SECTION 00911 - ADDENDUM 6

A. Project Name: South Main Corridor Improvement Project

C. Engineer's Project Number: 16-108.

D. Date of Addendum: March 12, 2021

C00.52

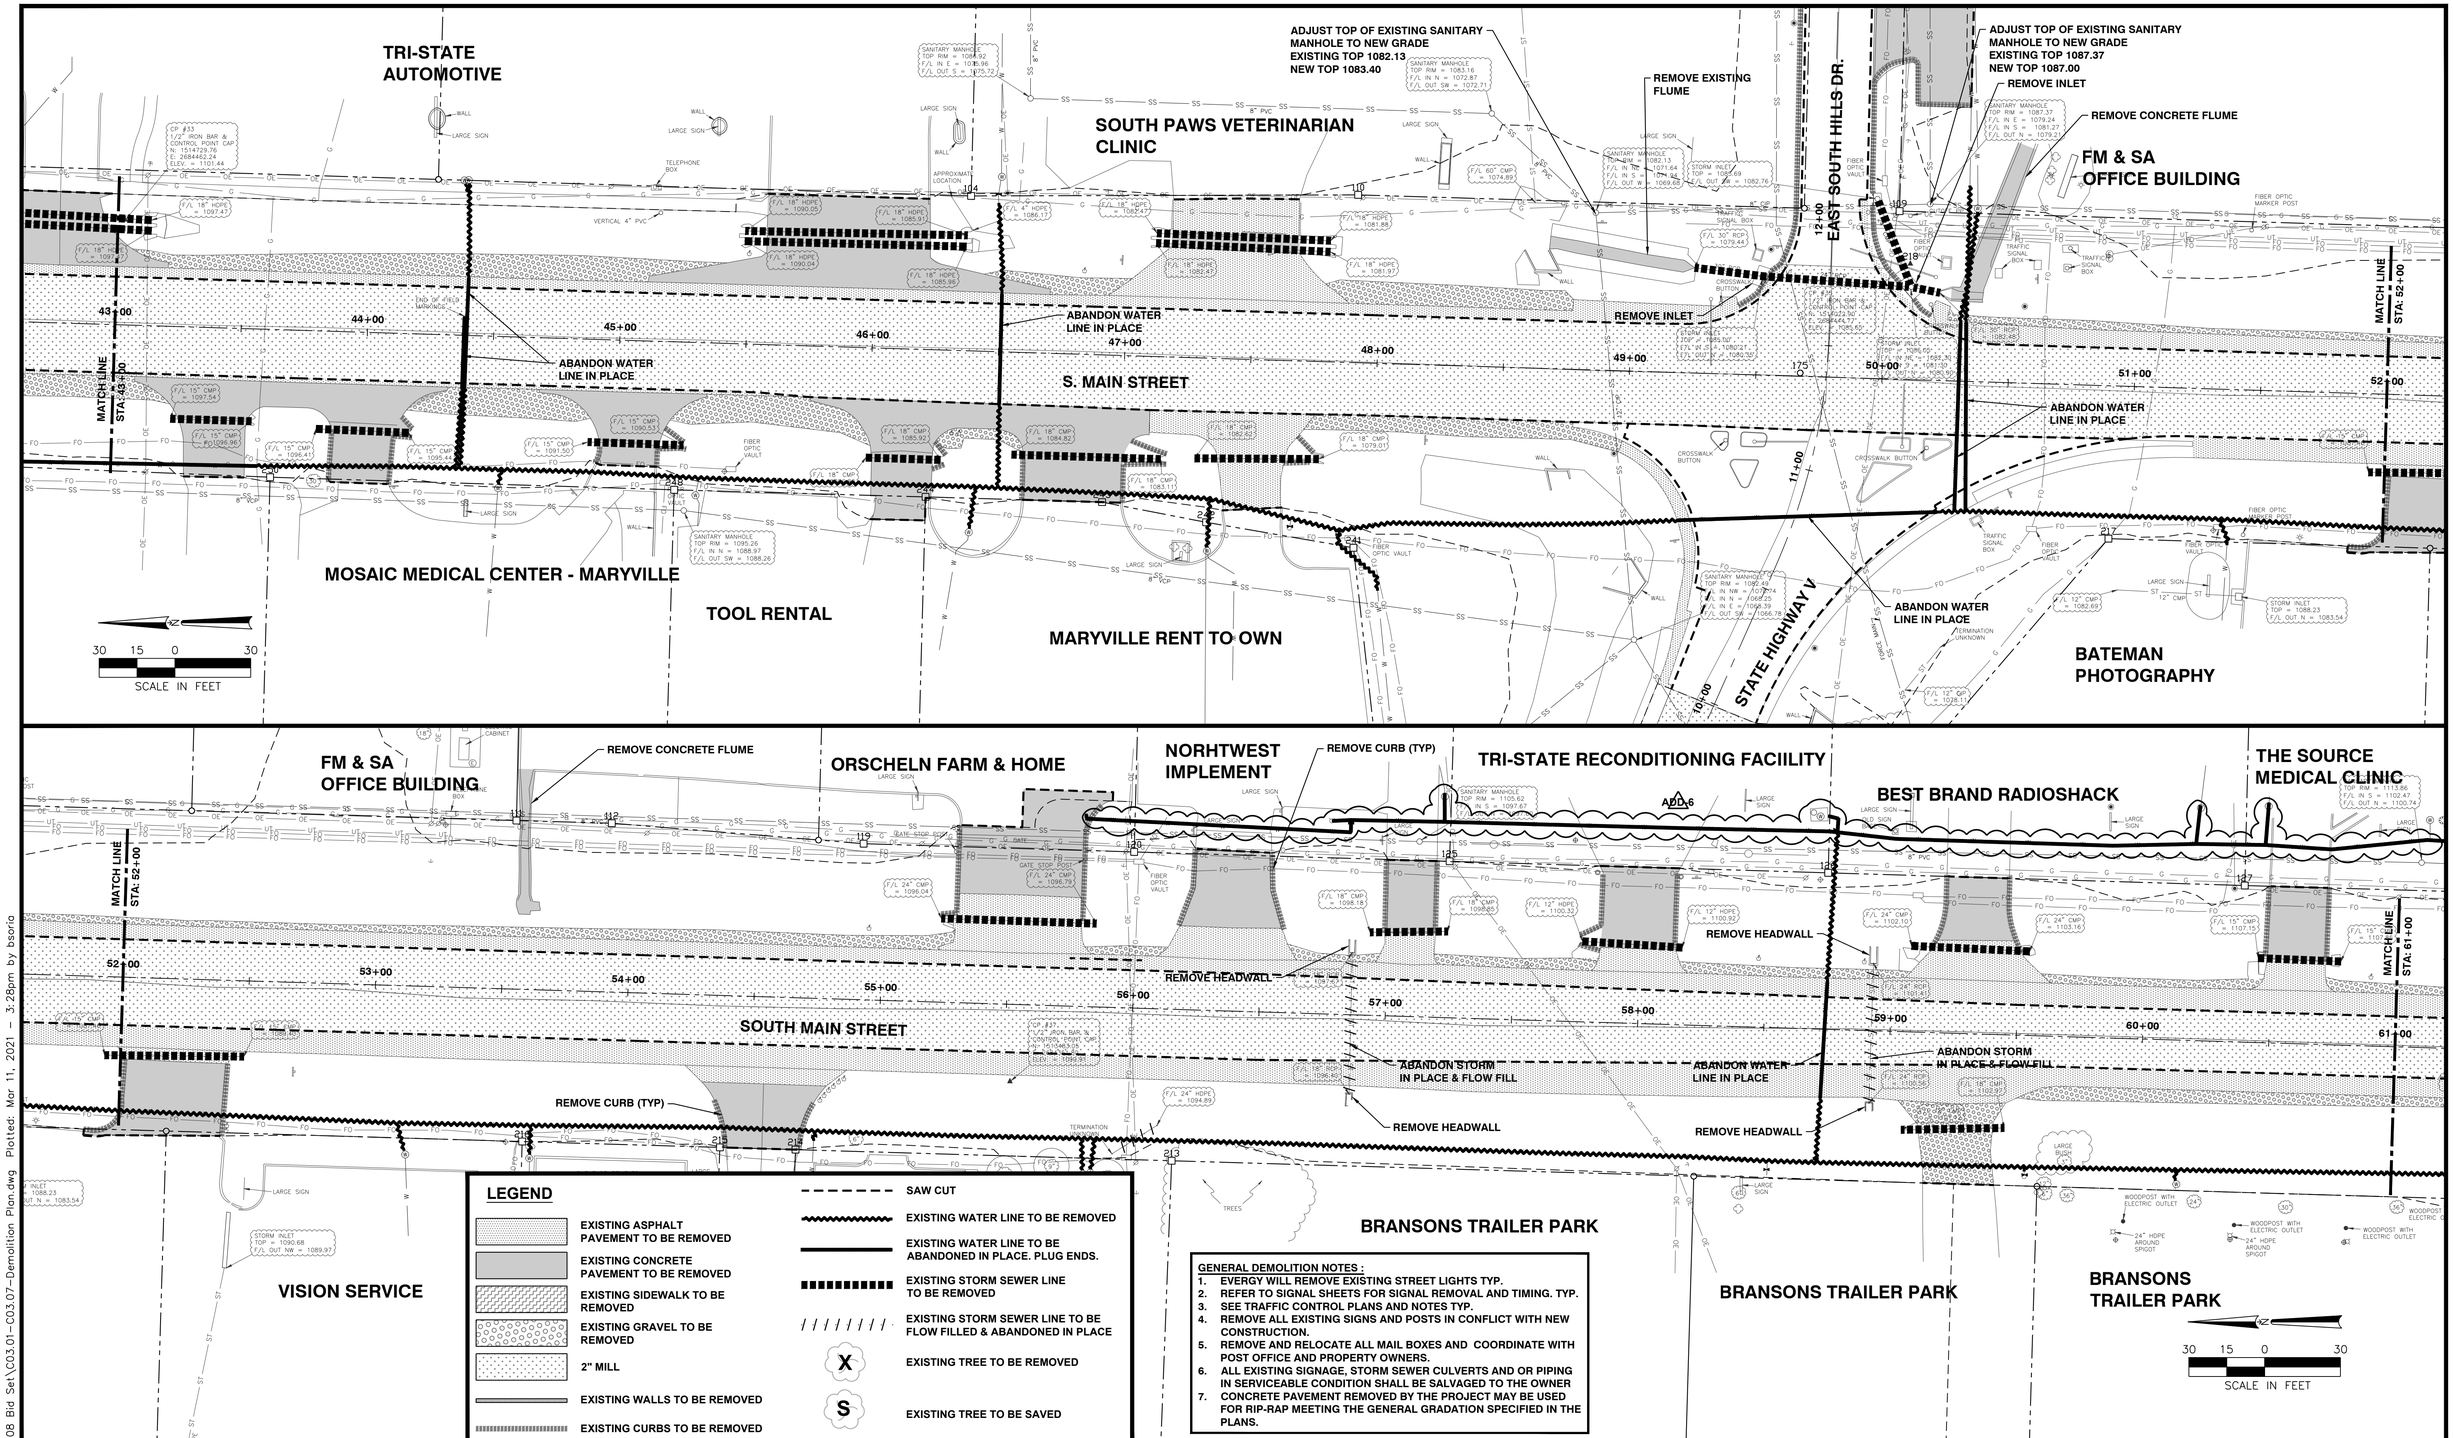
A. Delete the following drawing sheets in their entirety and replace with attached revised and clouded Addendum 6 drawings.
   1. Sheet C00.52 – Revised quantities

C03.05

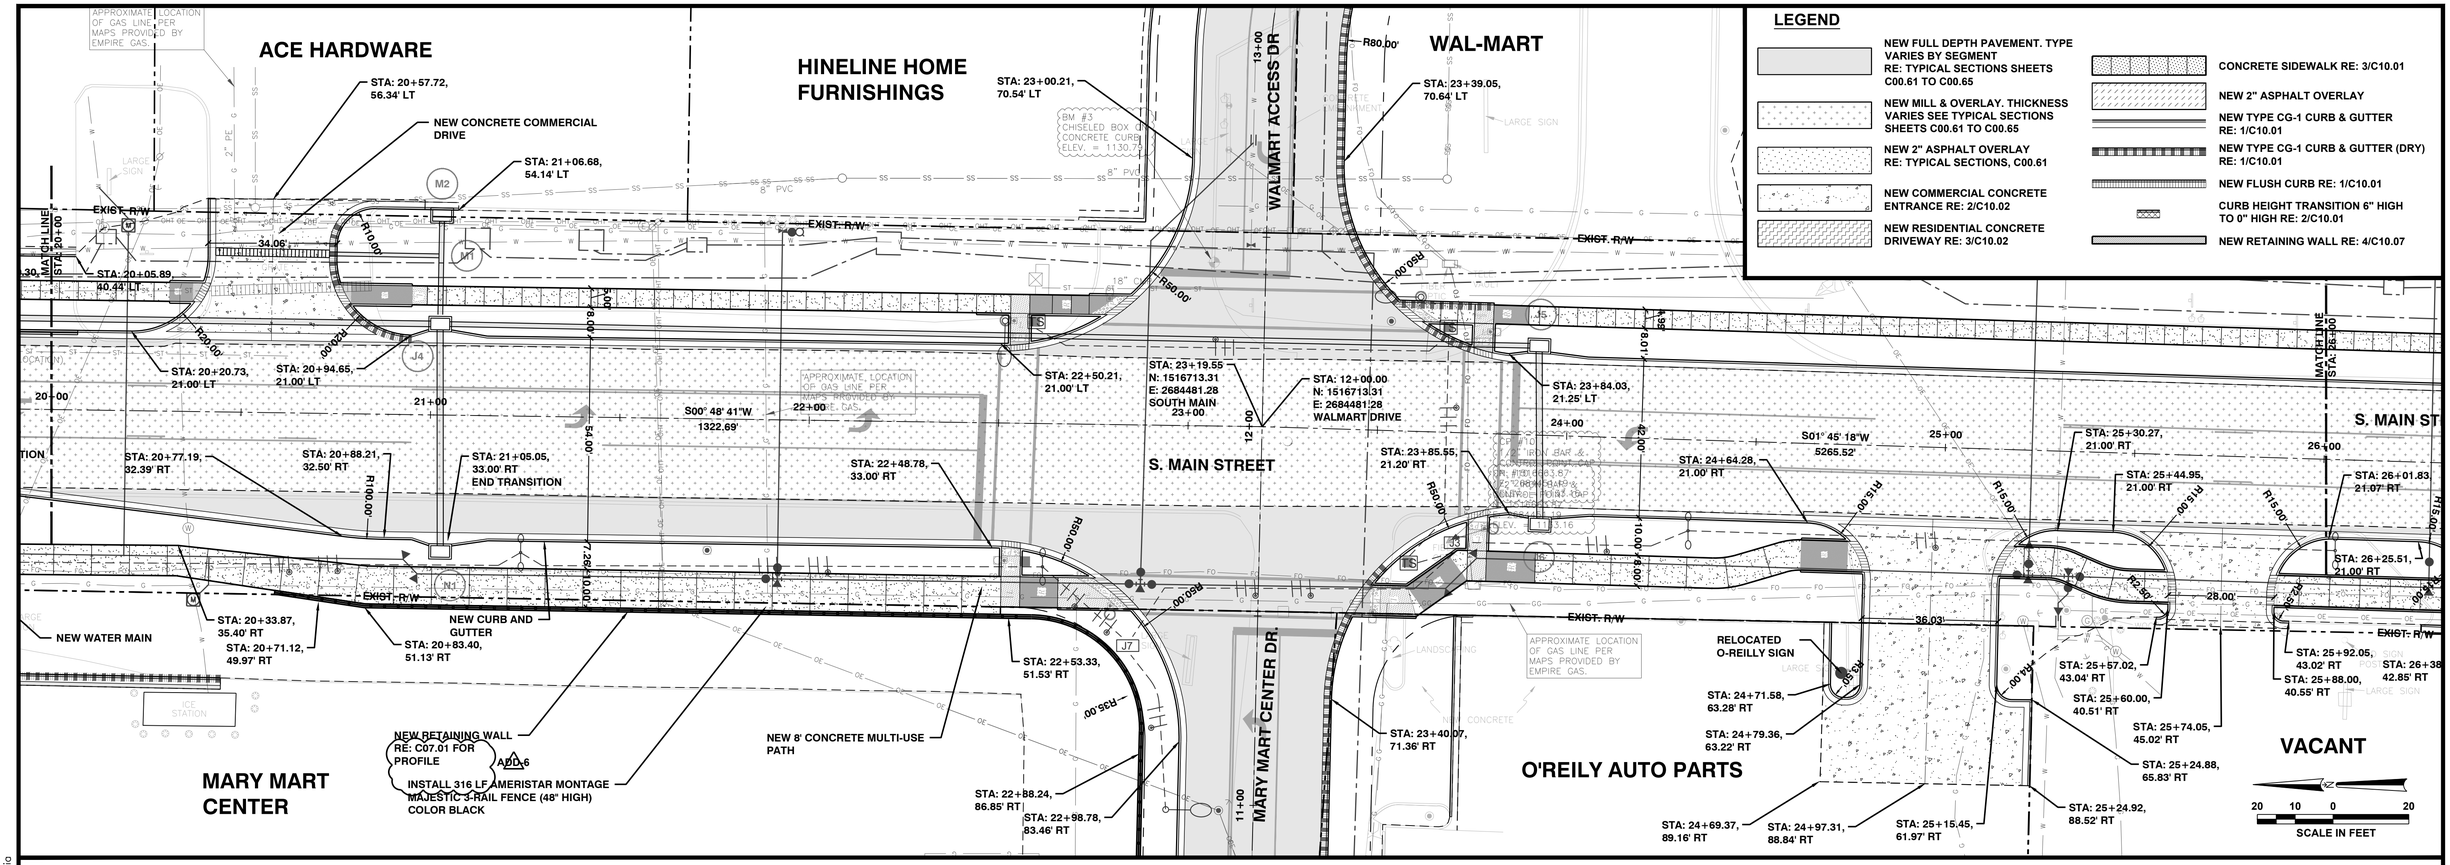
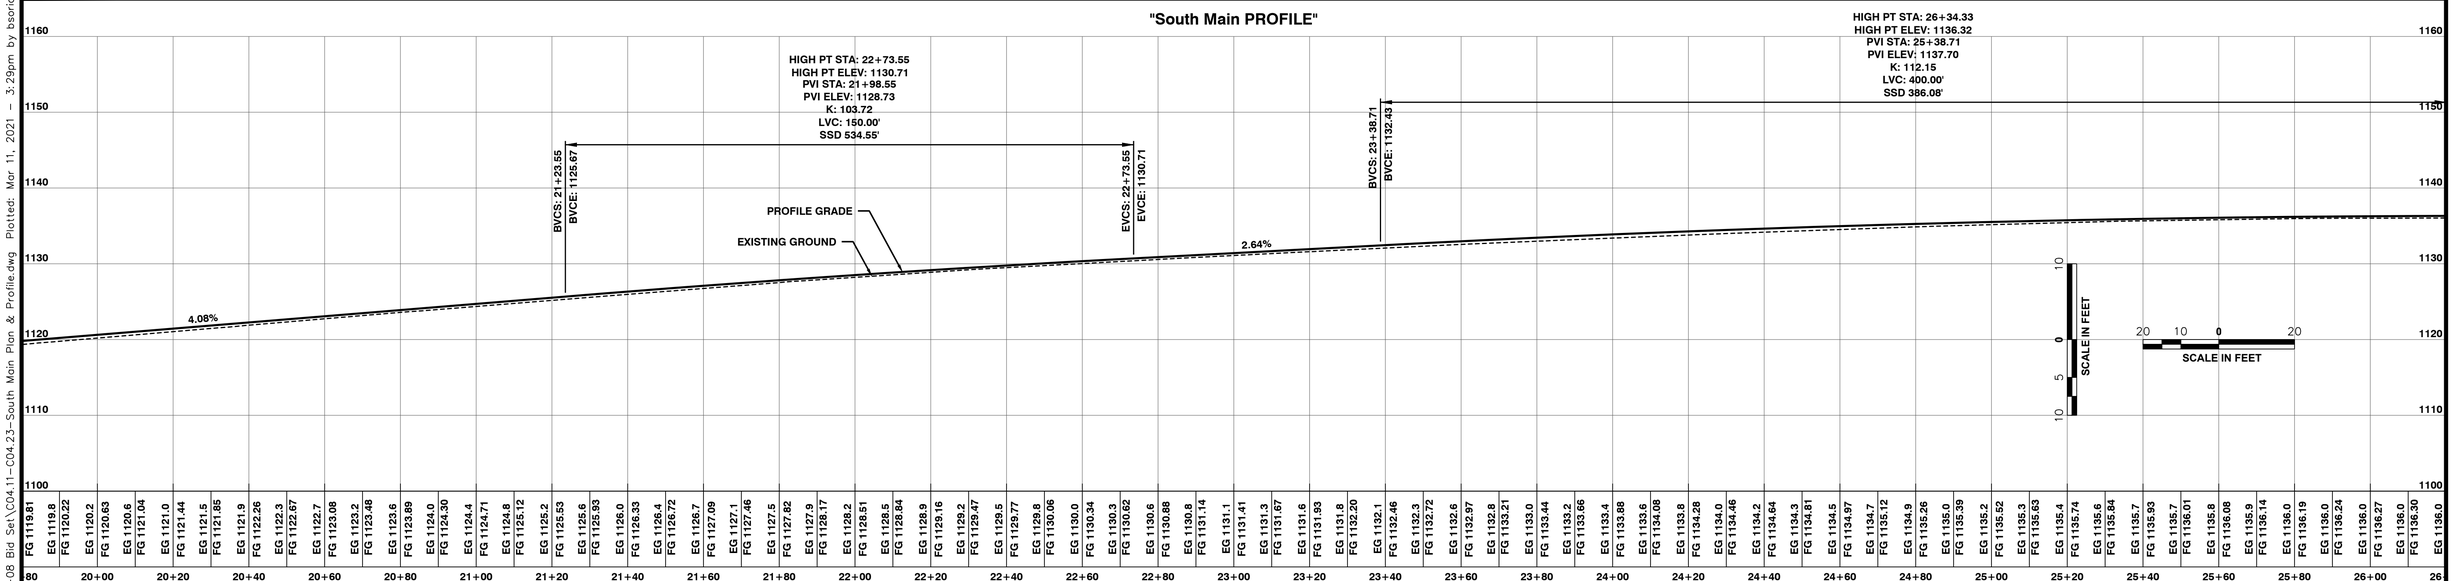
2. Sheet C03.04 - Revised limits of Existing Water main to be abandoned in place
   3. Sheet C03.05 - Revised limits of Existing Water main to be abandoned in place

C08.20

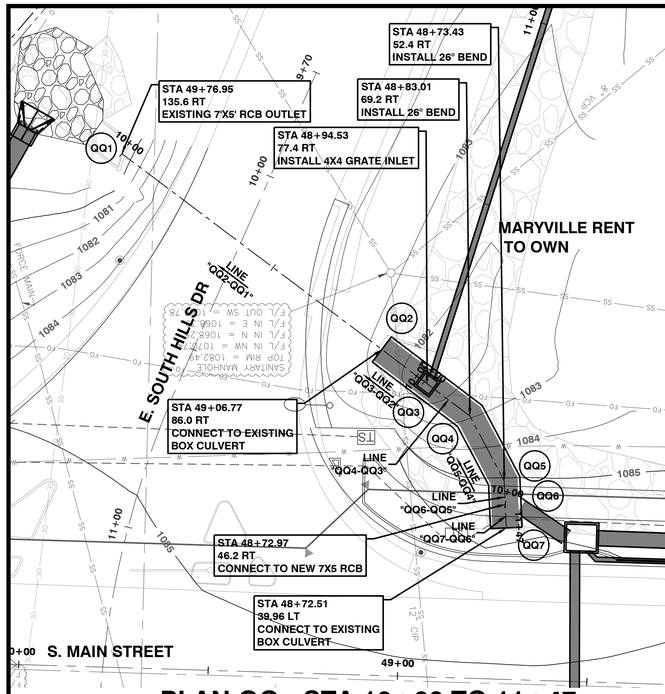
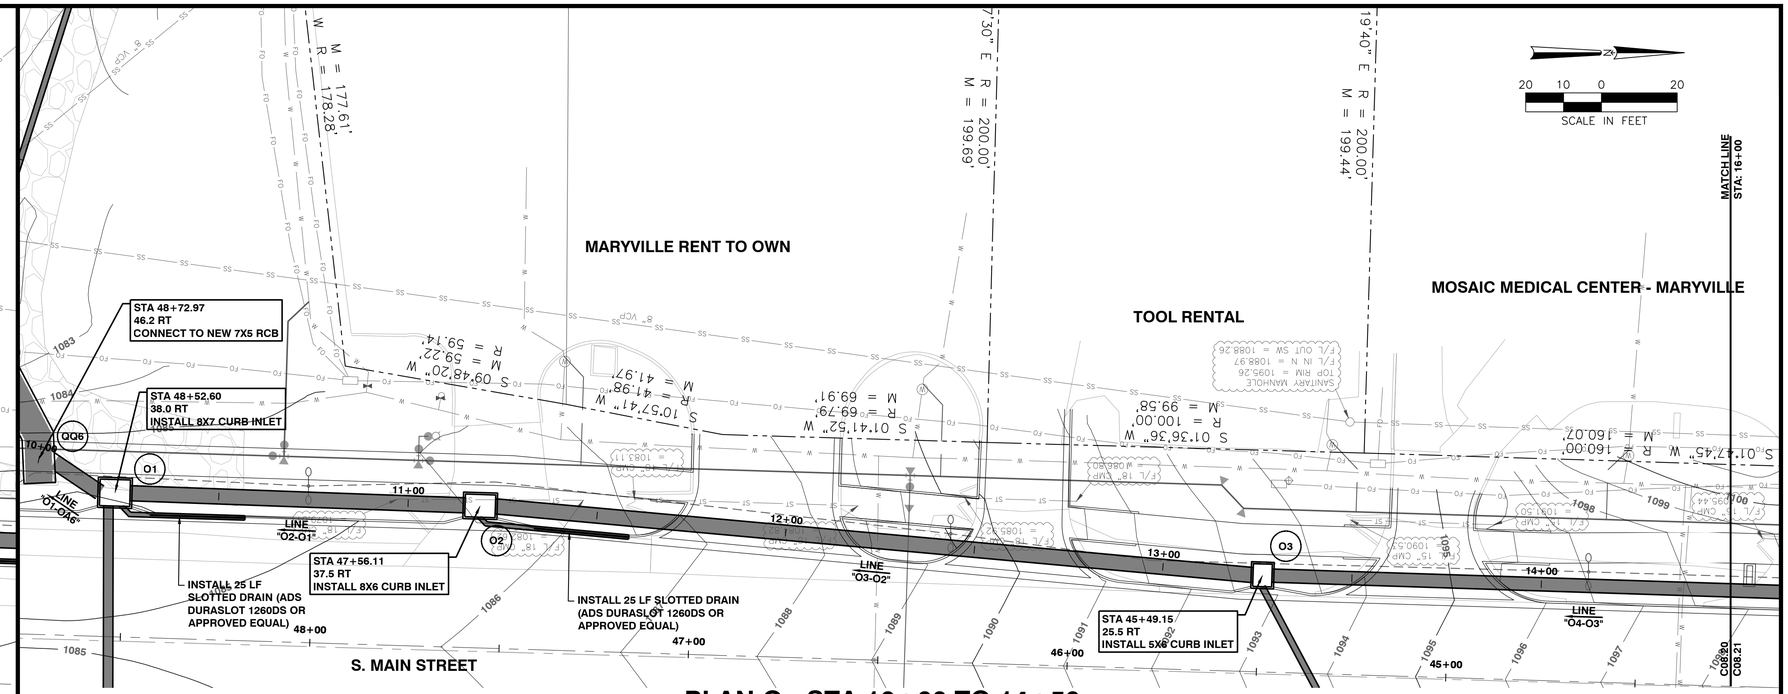
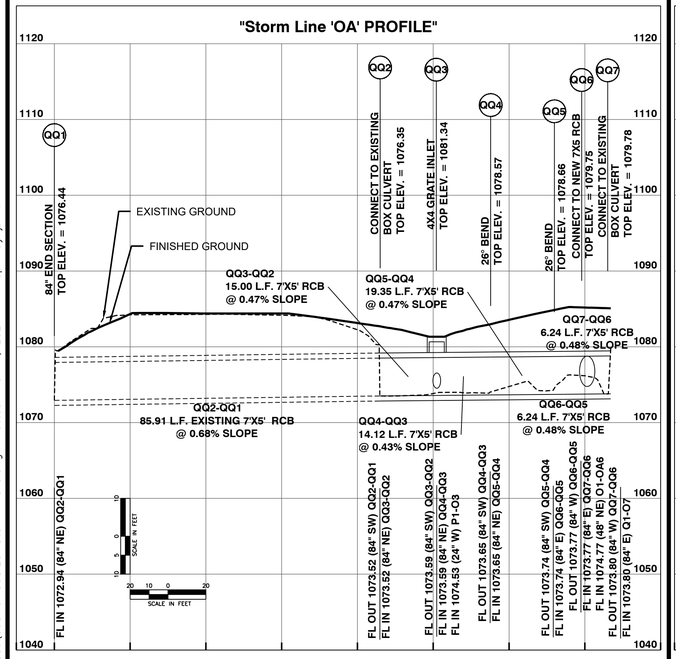
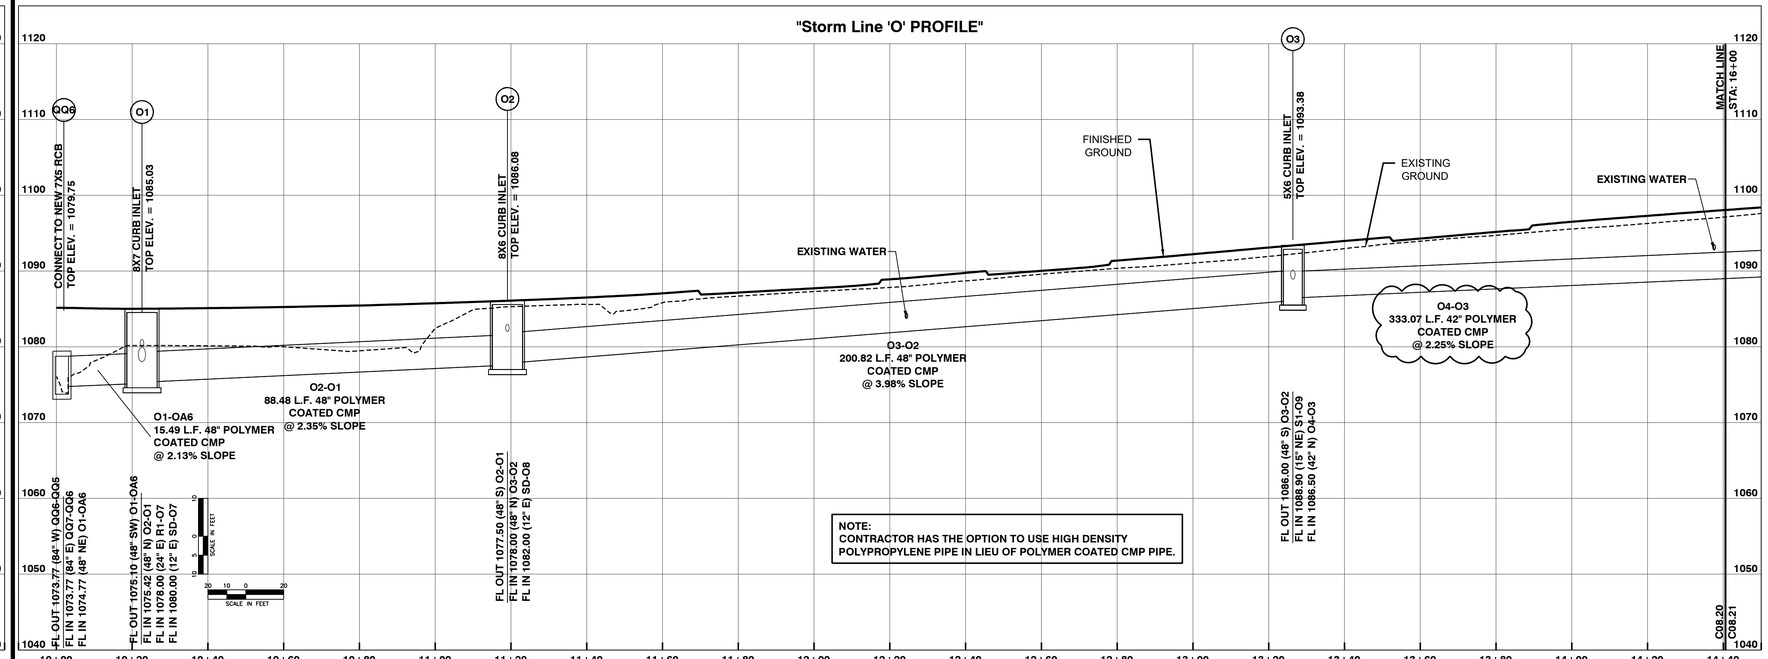
6. Sheet C08.21 - Updated profile as a result of upstream changes to avoid sanitary sewer conflict with pipe C7-C6.
   7. Sheet C08.22 - Updated profile to avoid sanitary sewer conflict with pipe C7-C6.
